Case Study

Electrical Protection & Grounding

United Illuminating Hqs. Facility

REVIEW OF EXISTING LIGHTNING INSTALLATION DESIGN AND STABILITY FOR INTENDED PURPOSE

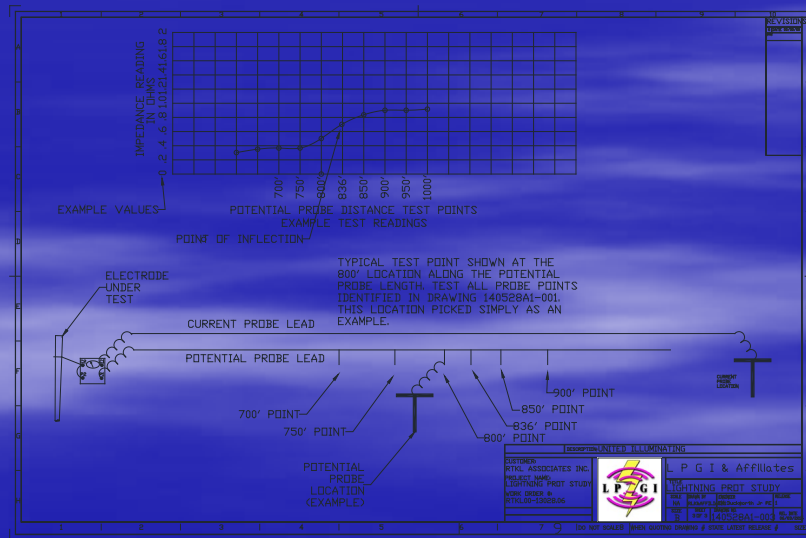
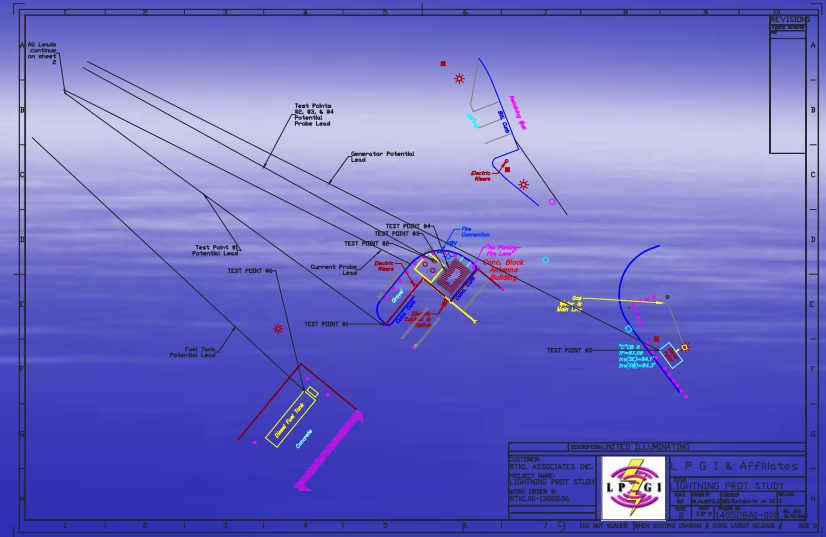
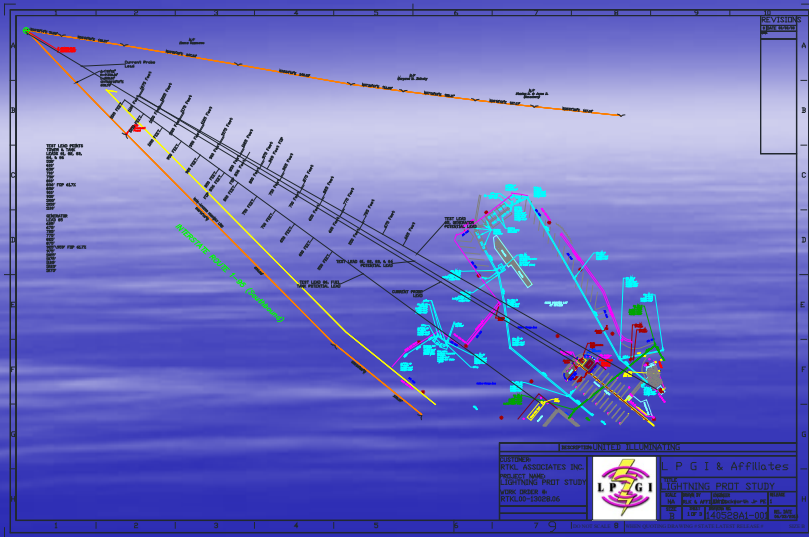
- Lightning installation performance at the United Illuminating Campus Facility is poor and will sustain significant equipment damage, throughout the campus facility, every time lightning strikes the radio tower. The possible damage from a lightning strike directly to the campus facility buildings, instead of the tower, will be less significant, because of a smaller more distributed surge being able to enter the facility campus ground.

- **The reasons are as follows:**
 - 1. Radio tower has no capacitive radial grounding system required to minimize radio tower GPR and direct currents away from the campus facility grounding system.

- 2. Radio tower and equipment building may not have a Single Point Ground (SPG)
 - 3. Radio tower's Halo Ground required to minimize the electro magnetic field within the building is not a complete closed circle. Note: it has been cut open and only an equipment ground (IERG) is to be left open at one end.

- **Other issues were noted that require correction.**
 - 4. Radio tower is bonded into the entire campus facility grounding system resulting in the entire magnitude of a lightning strike current flowing throughout the entire campus facility. This is the most significant problem with campus facility equipment damage.
